# Upgrading to the 21143-PD and 21143-TD

Application Note

*November 1998*

Figure 1. 21143-TD Package Marking Conventions

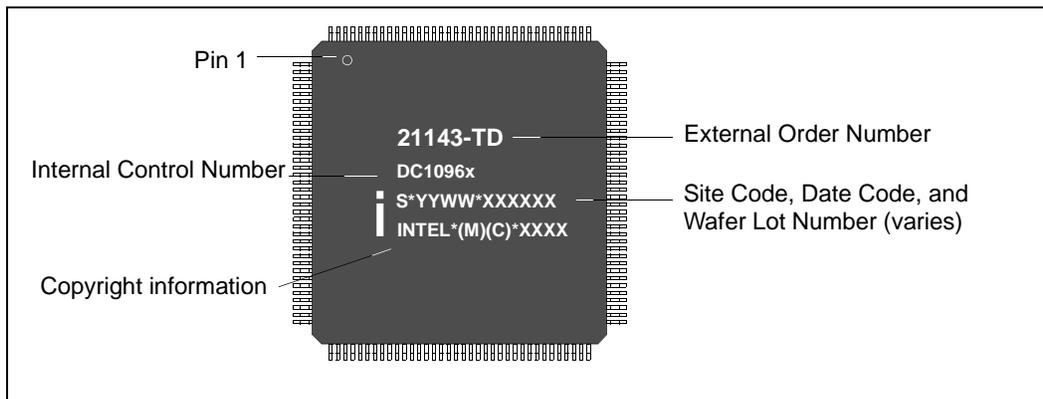
The 21143-TD device uses the following conventions (Figure 1) for package markings.

**Figure 2. 21143-PD Package Marking Conventions**

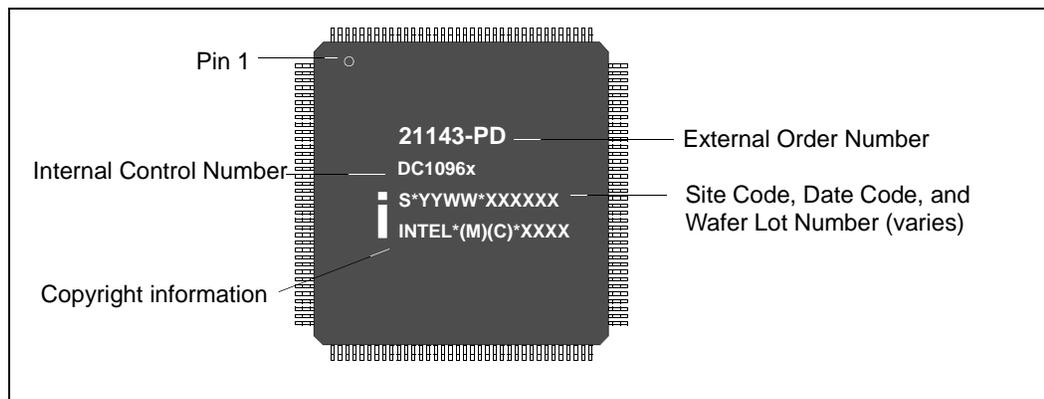
The 21143-PD device uses the following conventions (Figure 2) for package markings.
